PROJECT
 PROPOSED RESIDENCE
 OBCC No. - 1256130

LOCATION
 LOT 27 BANNER STREET
 GOLDSBOROUGH VALLEY

TITLE
 FLOOR PLAN

Subject: RE: Lot 27 Banner St Goldsborough
Date: Friday, 2nd October 2020 at 2:31:39 pm Australian Eastern Standard
From: Time Chas Gianarakis
To: Greenwood Constructions
Attachments: image002.jpg

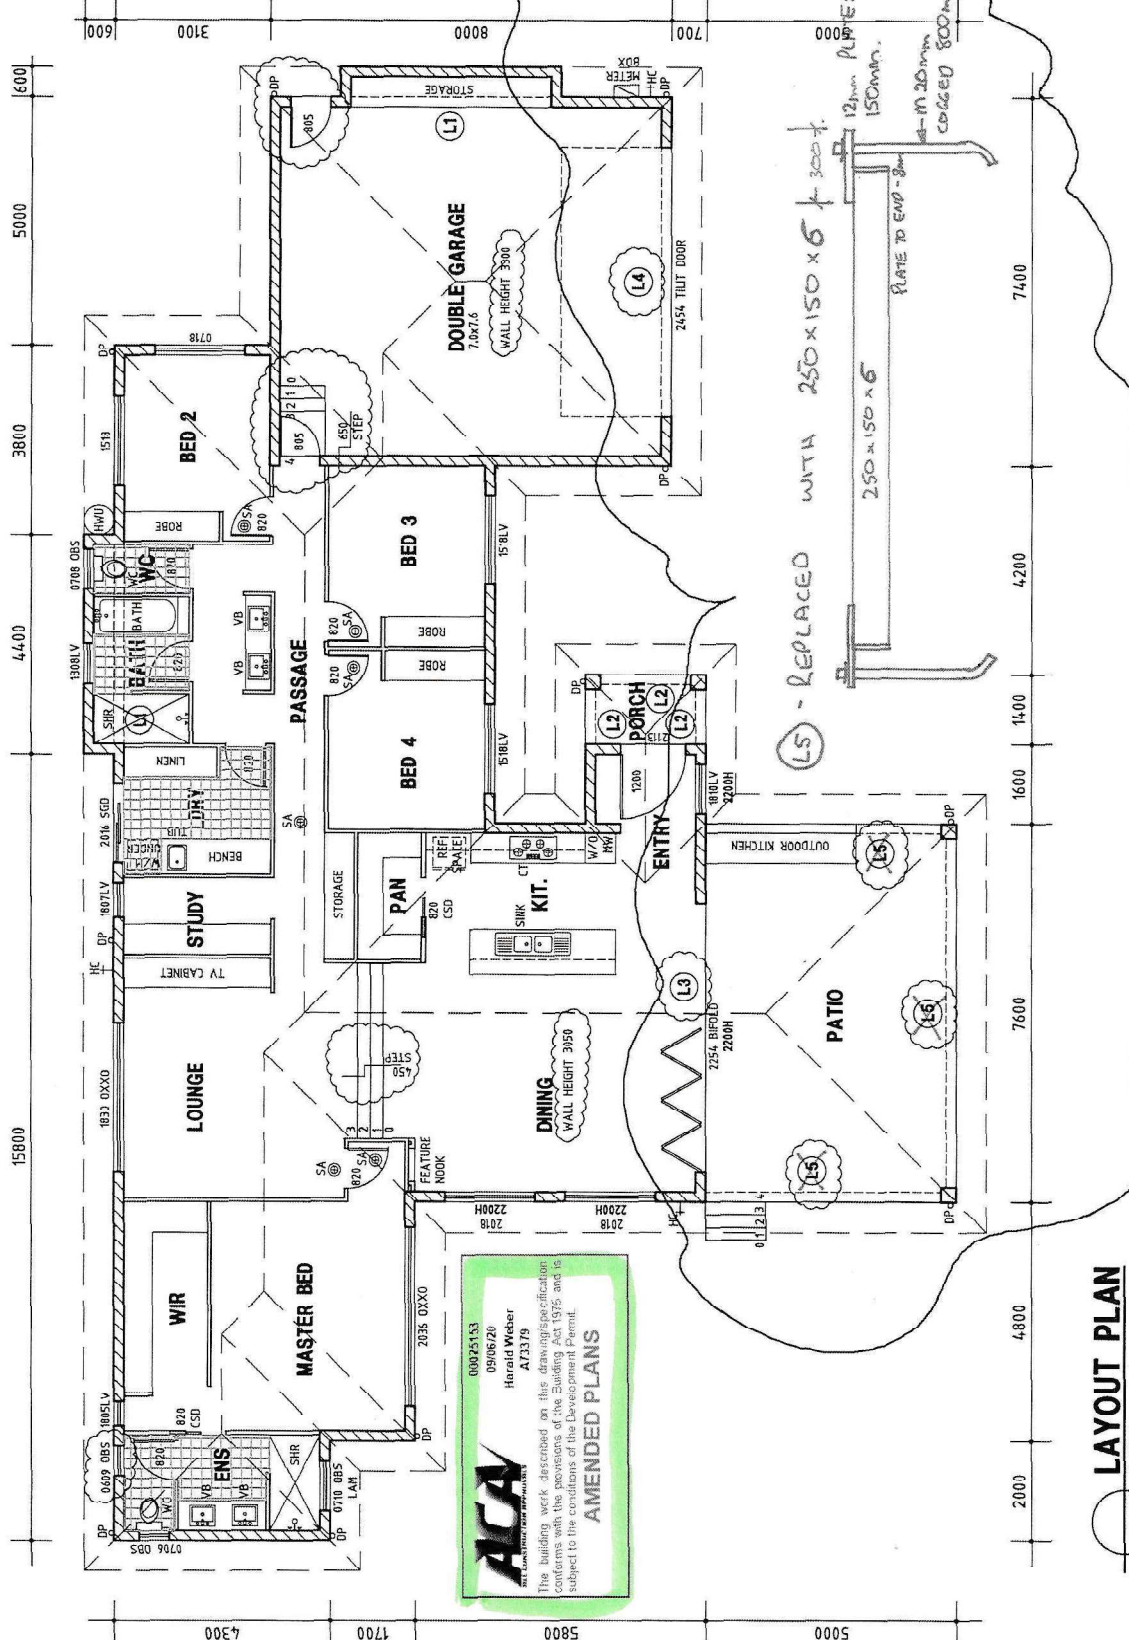
Please see attached and highlighted in green areas that the connection of SF1 to F2 were missed.

We have drilled 2 16mm bars to the blockwork with a 600mm lap to the trench mesh. Is this sufficient for the connection?

Can you please advise if my proposed mark ups will be an acceptable measure to stop the moisture coming between the footing and slab.

I think if we lay the extra visqueen in footing and continue to the under side of the slab should be adequate. If you feel extra is needed then I have contacted Fosrac which can supply a sealant called Hydratight which is a sticky back foam (12mm X 70mm) that sticks to the blockwork prior to pouring the slab.

I am asking if this will possibly work over the conventional way as drawn due to the extra cost factors associated.

We confirm the works undertaken as described below is structurally satisfactory.

The proposed alternative is structurally satisfactory provided N12 tie bars at 800cts max are placed between the strip footing and the lower slab.
